SERVICETEKNOTES

TABLE OF CONTENTS

PS501-1 POWER SWITCH RELIABILITY IMPROVED

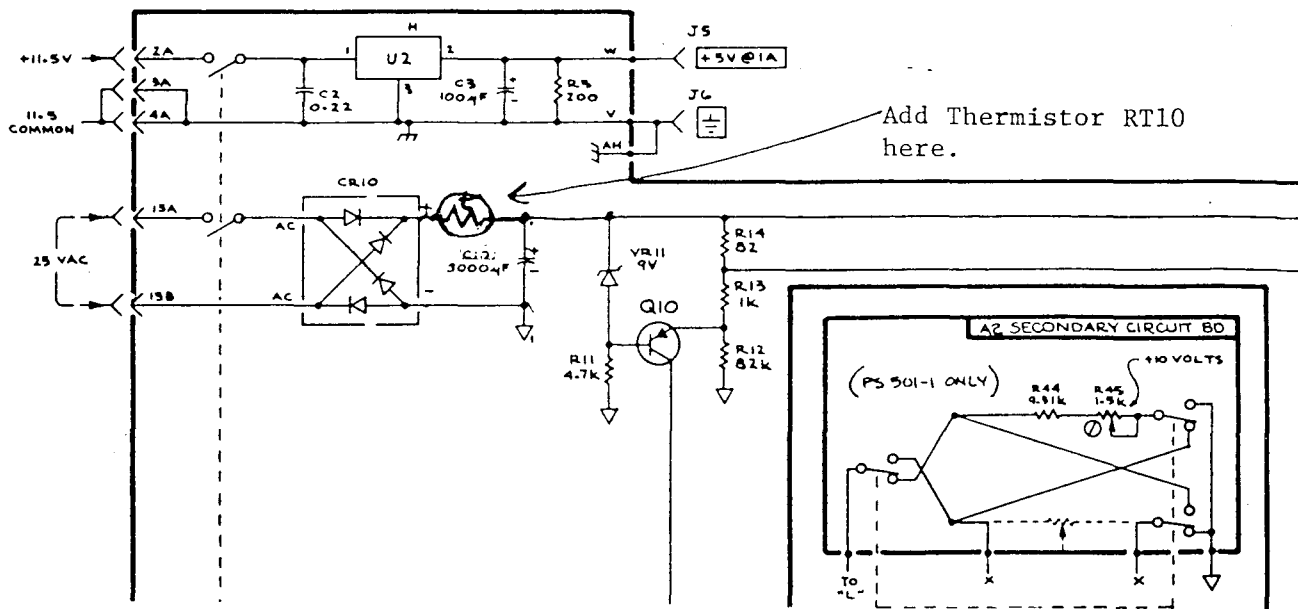
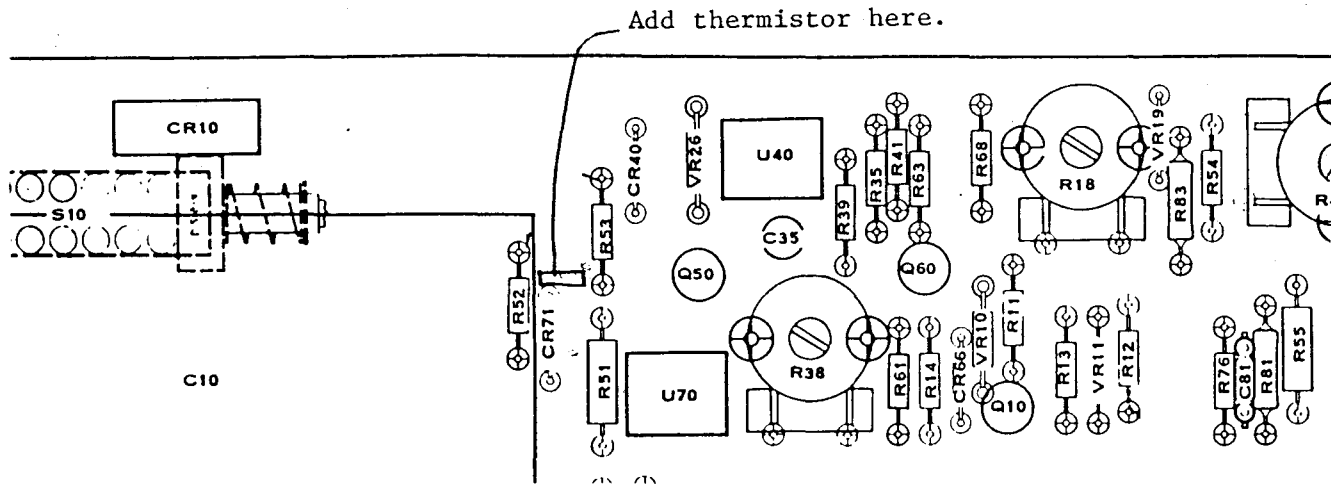
The reliability of the power switch S10 has been improved by reducing the surge current to C10 at turn-on. This has been done by adding a thermistor in series between the anode of CR10 and the positive lead of C10. The thermistor PN is 307-0746-00. This part is most easily installed by removing the upper bare wire attached to the plus terminal of C10 and replacing it with the thermistor. See attached drawings. This mod should be installed in every PS501-1 that is serviced.

Fig. 5-7. Equipment setup used to check TIM A-B accuracy.

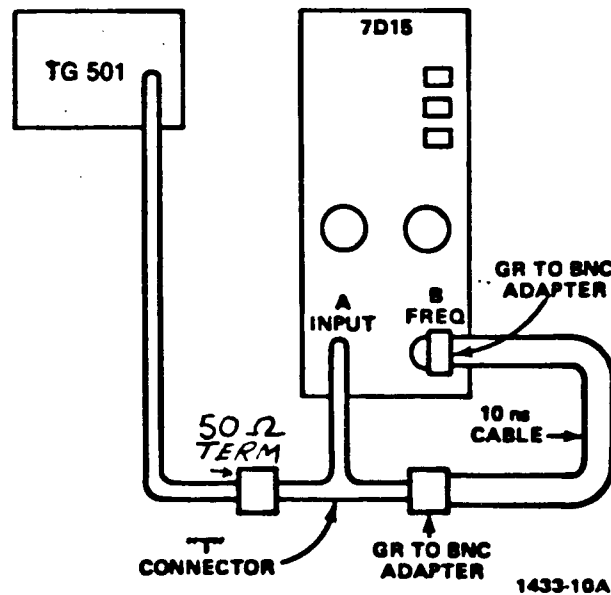
Change Figure 5-7 to the following:

Step 13, Page 5-11, TIM WIDTH A AND TIM A to B ACCURACY

Delete entire step g.

Change step i to read: Check for decreasing gate time (indicated by faster flashing of gate light) and constant readout display of 10 ns \pm 1 ns as the TG 501 is switched from 1 ms to 10 μ s.

Delete item number 7 from the required test equipment. (Pulse Generator)

Figure 1

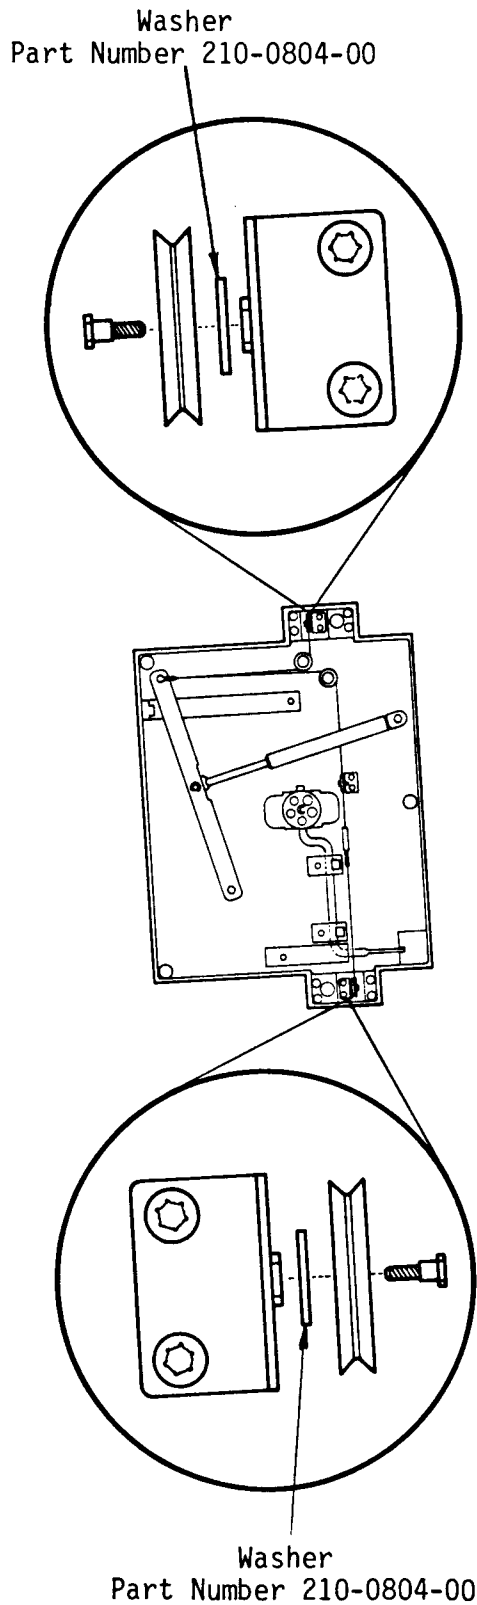
Several ADS01s have had trouble with two of the nylon pulleys pulling off at the bearing (refer to Figure 1). The problem has been identified, and a solution is available.

The solution is to add a 210-0804-00 (dimensions of washer .172 ID, .375 OD, and .30 thickness) steel washer between the pulley and mounting stud (refer to Figure 1).

Figure 1a.
Wire Harness for 118-0358-01, -02 and 118-1004-01

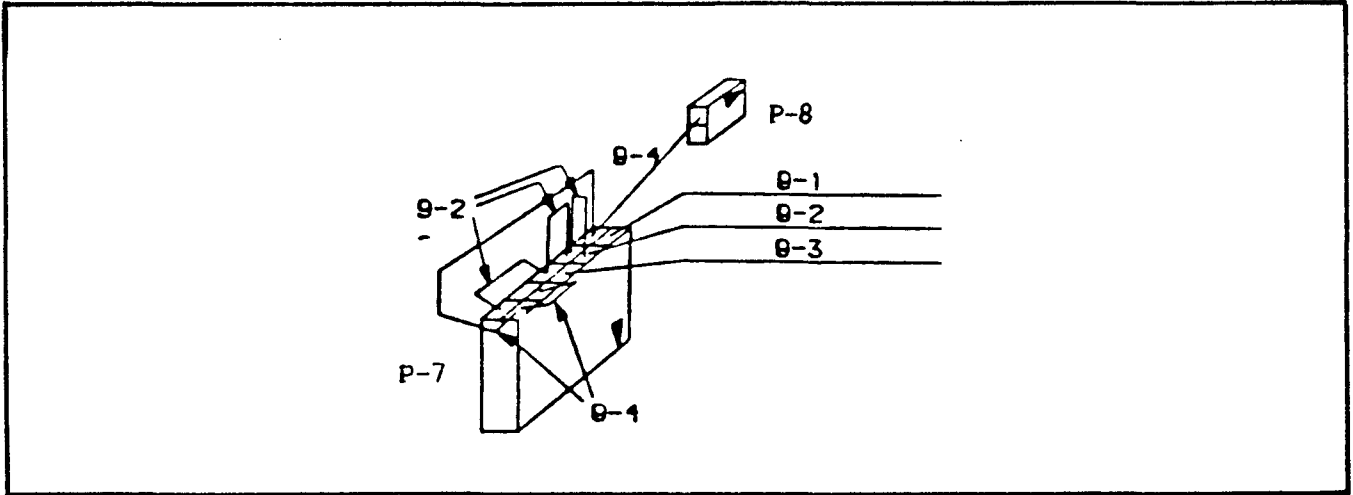
- 1) Place P-7 of this wire harness (shown in Figure 1a) on the board so connector pins 1 through 5 go over the square pins which connect to edge connector pins 2 through 10.
- 2) Place P-8 of the wire harness on pin set D of the board so the wire of P-8 is connected to the square pin which is toward the inside of the board.
- 3) Solder the 9-1 wire to the through hole connections to pin 3 of IC 2F.
- 4) Solder the 9-2 wire to the middle square pin of the NP/WP pin set.
- 5) Solder the 9-3 wire to the through hole located between ICs 3C and 3D (see Figure 4).

Figure 2.
Wire Set for 118-1004-02

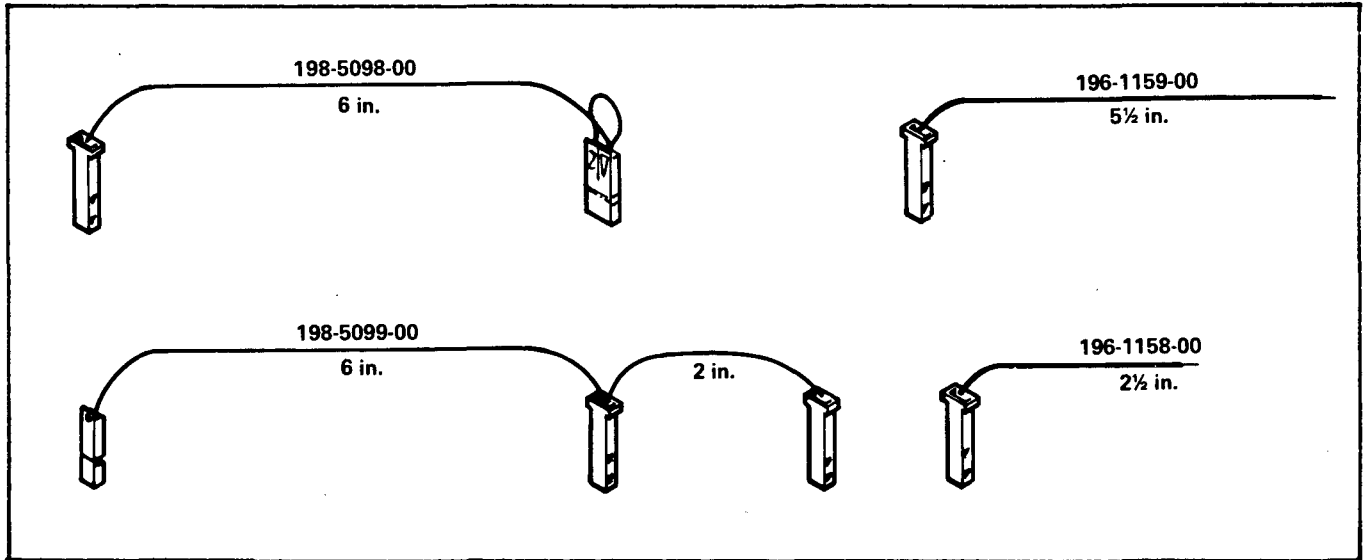
Refer to Figure 6 for locations of the wire to be attached in the following procedures. Refer to Figure 2 for description of the wires used in this procedure. Note that the 198-5099-00 wire is not used in the 4907.

Figure 3.
118-1004-02 Wire Set Edge Pin Connections

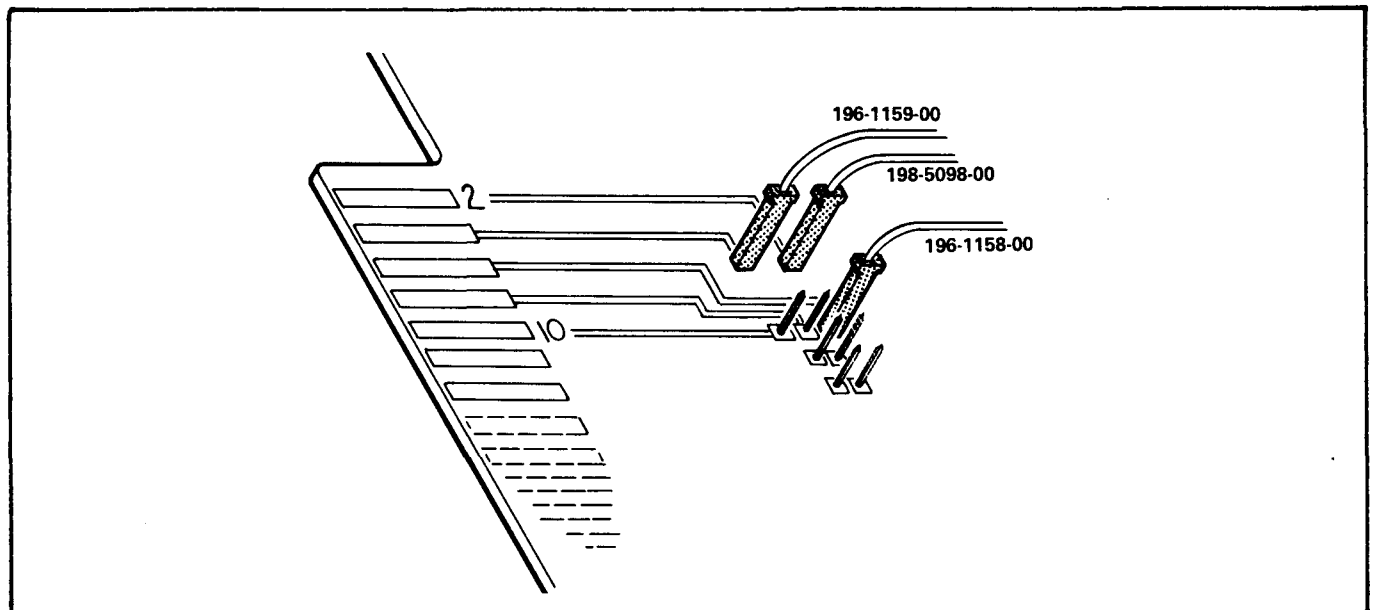
- 1) Solder the stripped-lead end of the 196-1158-00 wire to the feedthrough connected to pin 13 of IC 2A.
- 2) Connect the other end of the 196-1158-00 wire to the square pin connected to Pin 6 of the edge connector as shown in Figure 3 below.
- 3) Connect the single-pin-connector end of the 198-5098-00 wire to the square pin connected to Pin 2 of the edge connector as shown in Figure 3.
- 4) Connect the other end of the 198-5098-00 wire (double-pin) to the square pin labeled Z of the Y/EZ/Z jumper so the other side of the double-pin connector is left open (not on a square pin).
- 5) Check that one end of the 196-1159-00 wire is soldered to the feedthrough connected to the WP side of the NP/WP square pads.
- 6) Connect the other end of the 196-1159-00 wire to the square pin connected to Pin 4 of the edge connector as shown in Figure 6.

Figure 4.
Board Layout for 118-0358-01, -02

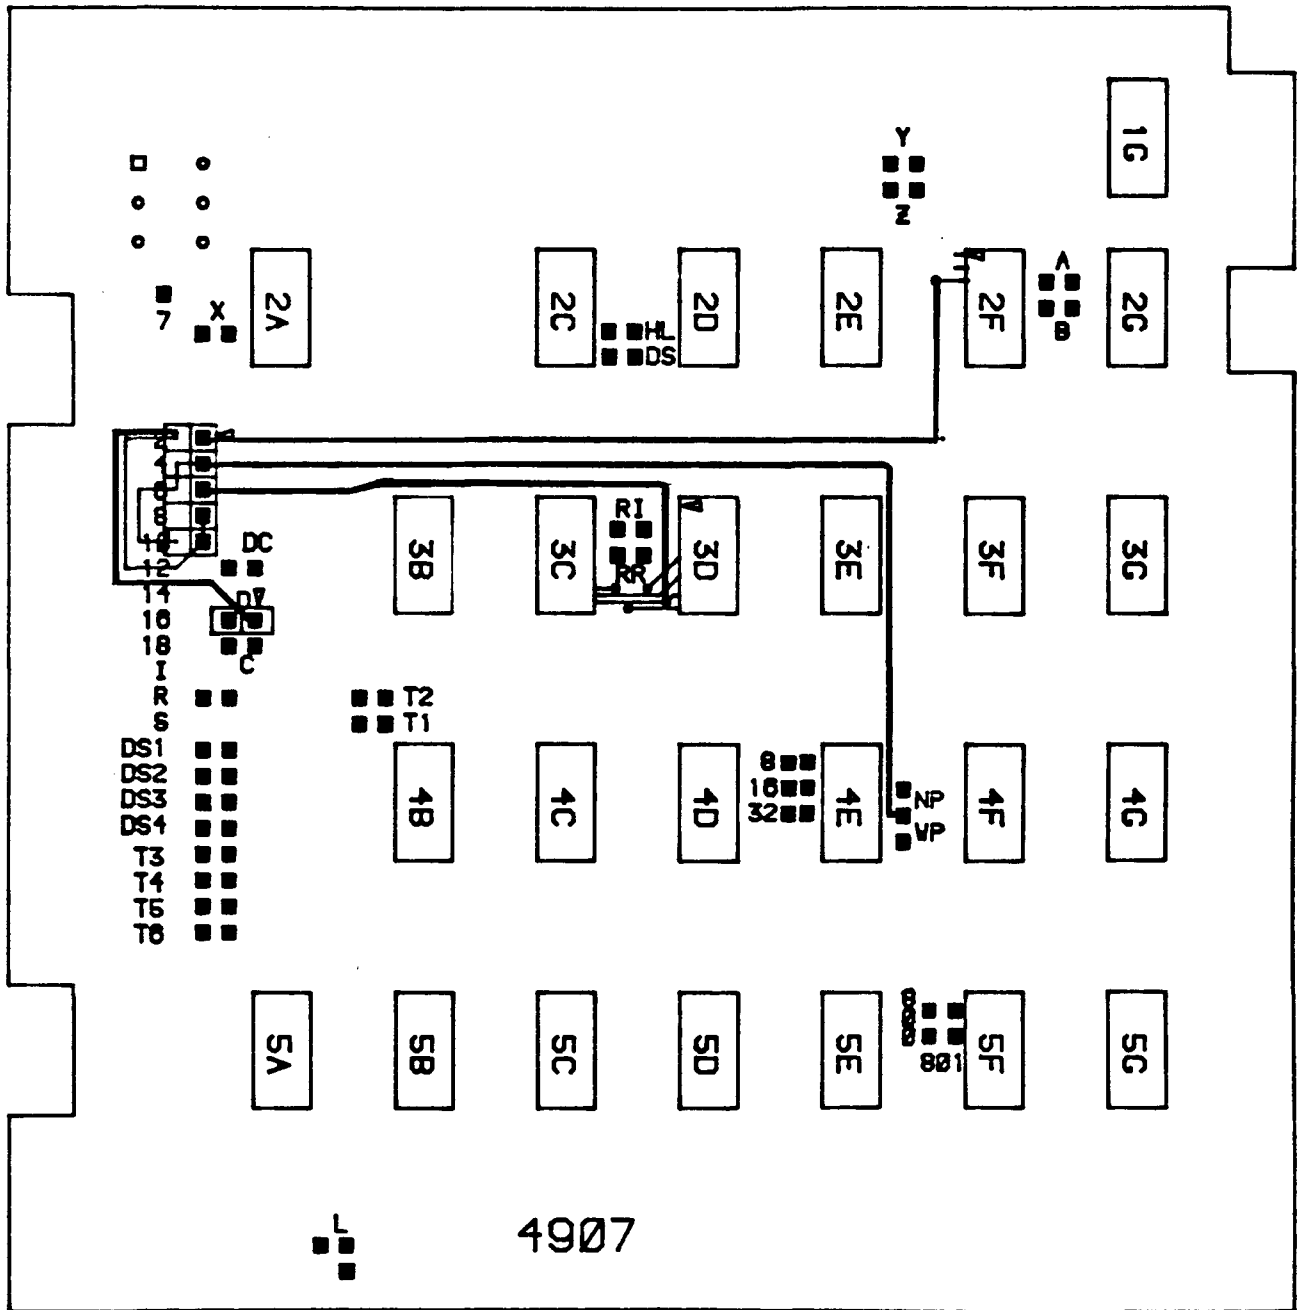
Refer to Figure 4 for locations of the wire to be attached in the following procedures.

Figure 5.
Board Layout for 118-1004-01

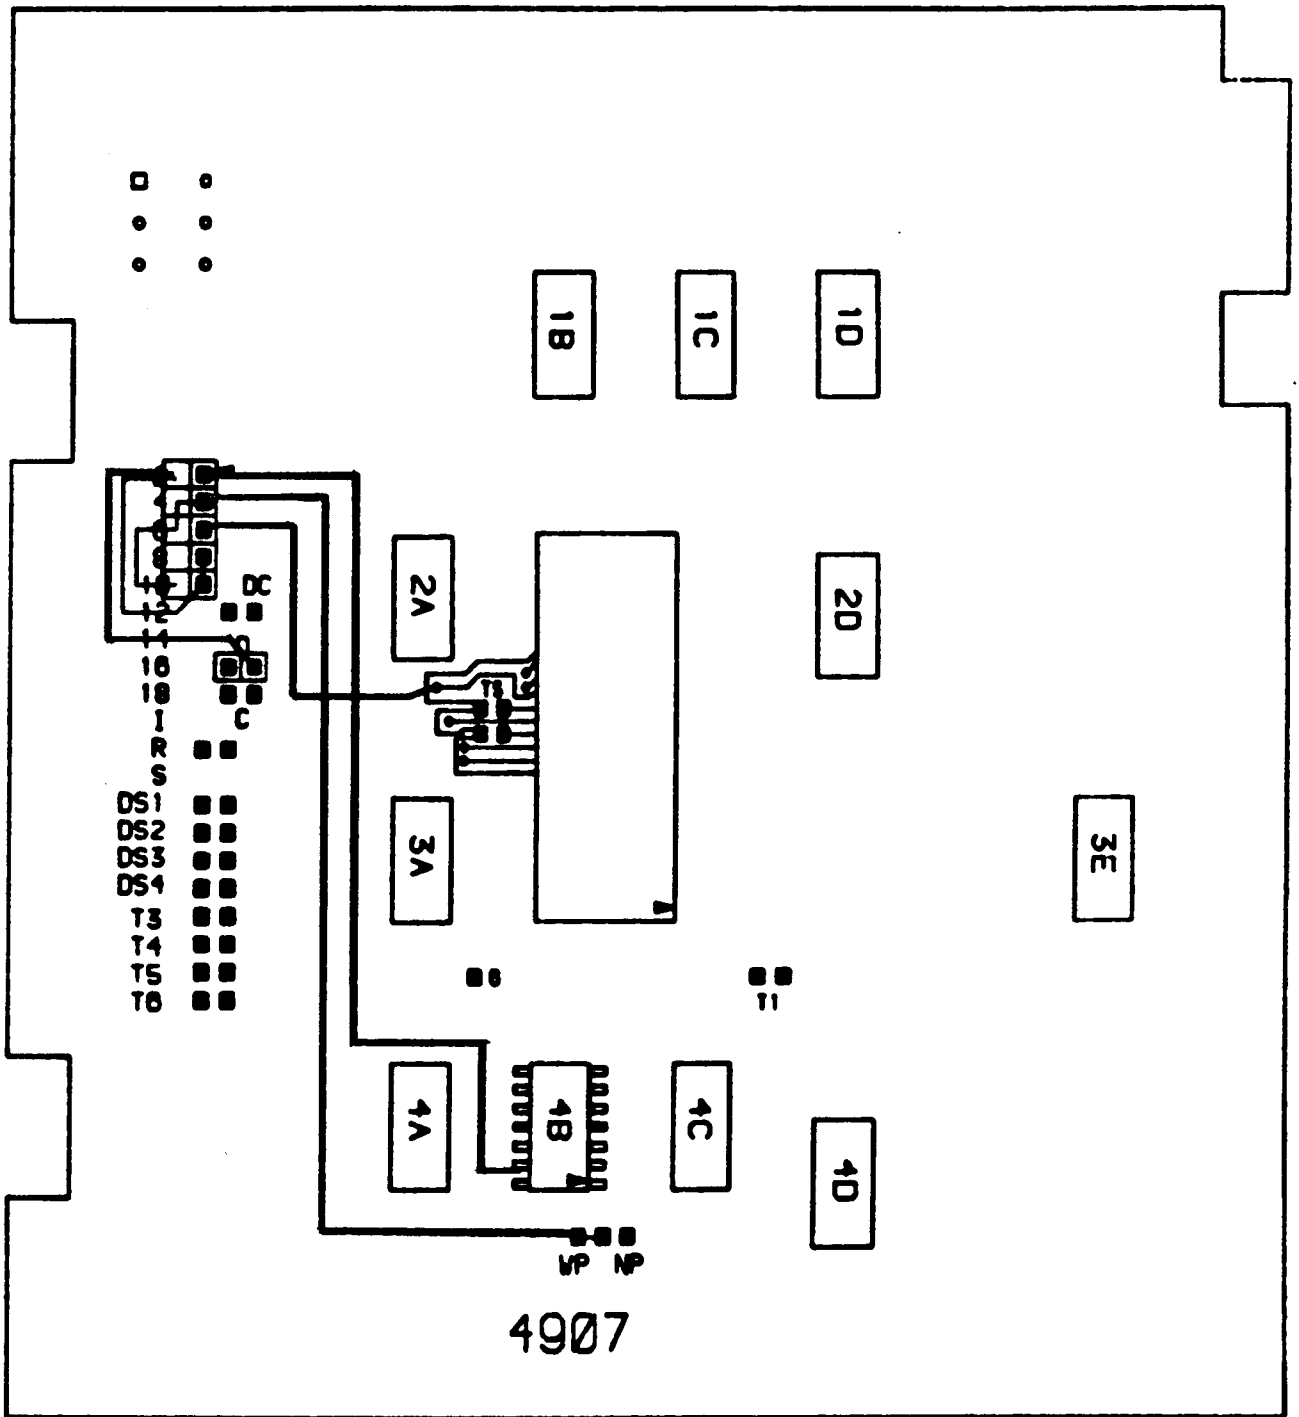
Refer to Figure 5 for locations of the wire to be attached in the following procedures.

- 1) Place P-7 of the wire harness (shown in Figure 1a) on the board so connector pins 1 through 5 go over the square pins as shown in Figure 5.
- 2) Place P-8 of the wire harness on pin set D of the board so the wire of P-8 is connected to the square pin which is toward the inside of the board.
- 3) Solder the 9-1 wire to the through hole connecting to pin 13 of IC 4B.
- 4) Solder the 9-2 wire to the WP square pin of the WP/NP pin set.

- 5) Solder the 9-3 wire to the through hole located between ICs 2A/3A and the LSI IC as shown in Figure 5.
